Hornsea Project Three  
Offshore Wind Farm

Statement of Common Ground between Hornsea Project Three  
(UK) Ltd. and Highways England

Date: November 2018

## 5. Appendix “a” - Applicant’s Response to Highways England Briefing Note 01A

**Figure 2.1 – Crashmap A47/Taverham Road Junction Assessment**

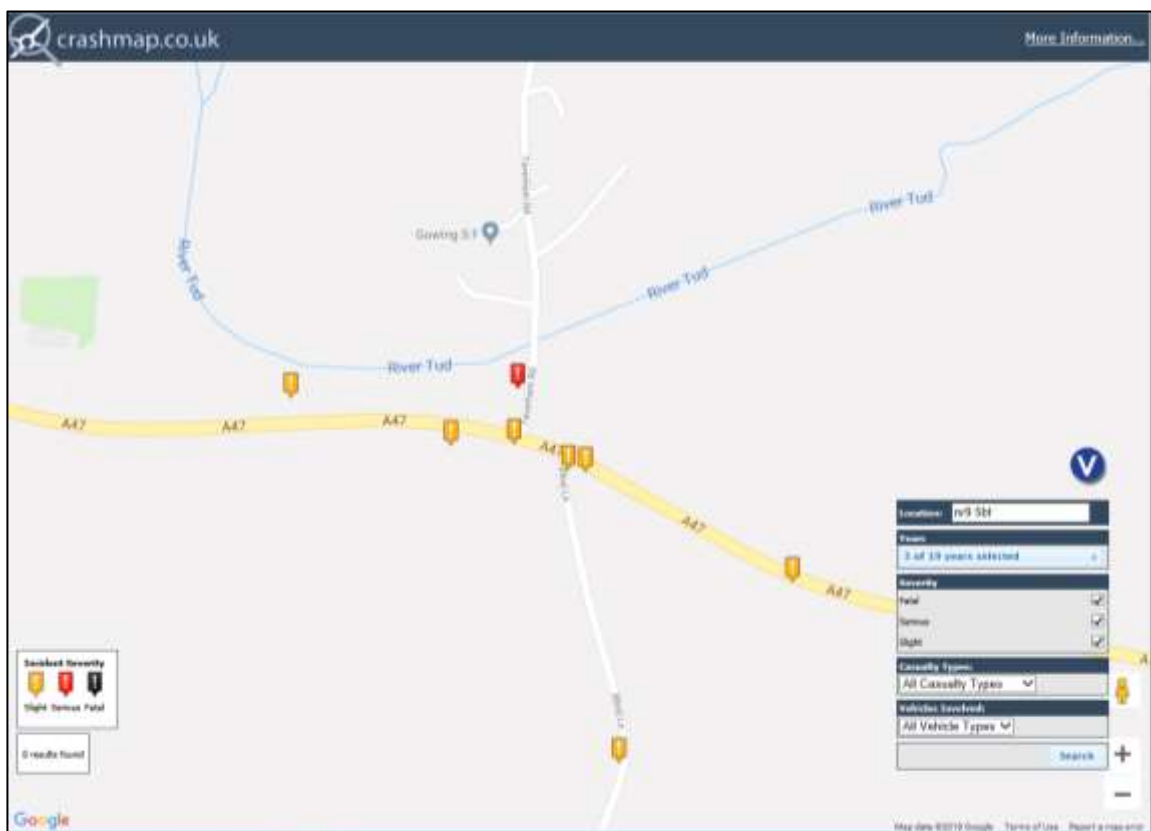
- *An assessment of the current junction layout against the requirements of DMRB design standard TD42;*
- *An assessment of the collision record of this junction;*

*“No assessments of this nature are included in the TA or its supporting documentation.*

*Table 1.5 of the TA lists two construction site accesses as being accessed via the A47/ Taverham Road junction. These are listed as sites 16 (B) and 17 (B) although on the plan at Sheet 7 of ES Annex 7.8, it would seem more logical to serve sites 17 (B) and 18 (B) from Taverham Road and 16 (B) from Church Lane, Easton. Appendix A shows the total traffic generated by sites 16 (A), 17 (B) and 18 (B) as being 31 two-way light vehicle and 99 two-way HGV movements per day. It would be reasonable to assume that this traffic will be split equally across the three access points, therefore the A47/ Taverham Road junction would have to accommodate up to 66 two-way HGV movements per day. This is unlikely to require a junction capacity model. However, the underlying suitability of this older-style priority junction needs to be questioned for the reasons stated at para 24 above. An assessment of the junction’s layout against DMRB standards and the provision of HGV swept path plots to demonstrate its adequacy to accommodate an influx of larger vehicles, together with an assessment of the collision record here would be advisable. It is of note that a collision analysis was undertaken for the A47 to the west of Easton (TA paras 1.4.2.16 – 1.4.2.23) but this covered a section some 2-3km to the west of here and did not include this junction.*

*Further assessments as recommended above would be beneficial. Alternatively, from the perspective of the safe and free flow of traffic on the Trunk Road, it might be preferable to serve all three access points 16(B) 17(B) and 18(B) from the A47/ Easton roundabout via Church Lane (highway link 126) rather than from Taverham Road (link 125).”*

- 7.20 To address the AECOM concerns regarding the A47/Taverham Road junction a review of road safety has been carried out using the “Crashmap” recorded personal injury accident database. The review includes three years of accident data to the end of 2017 as shown in Figure 2.1 below:

- 7.21 The Crashmap data depicted in Figure 2.1 shows that only one accident occurred on the A47 immediately adjacent to the Taverham Road junction. This accident is classified as ‘Slight’ in severity and was recorded on the 15 January 2016 involving two vehicles resulting in one casualty.
- 7.22 Figure 2.1 also shows an accident recorded on Taverham Road approximately 35m north of the junction with the A47. This accident occurred on 26 July 2017 and is classified as ‘Serious’ in severity involving two vehicles and one casualty.

- 7.23 The next closest accident to the A47/Taverham Road junction was recorded on 4 May 2018, approximately 50m to the west on the A47. This incident was classified as 'Slight' in severity involving two vehicles and two casualties.

- 7.24 The two accidents shown to the east of Taverham Road along the A47 are more closely linked to the Blind Lane junction to the south and therefore are not relevant to this assessment.

- 7.25 In addition to the Crashmap data analysis outlined above, further analysis has been undertaken using collision data obtained from Norfolk County Council for an extended five year period to the end of August 2018, included at Appendix C. This more detailed account of collision data shows there to be no issues with HGV traffic turning to/from Taverham Road within the immediate vicinity of the A47/Taverham Road junction.

- 7.26 Consequently, it can be asserted that there are no prevailing accident issues associated with the A47/Taverham Road junction arrangement and this is likely to remain so with the introduction of Hornsea Three.
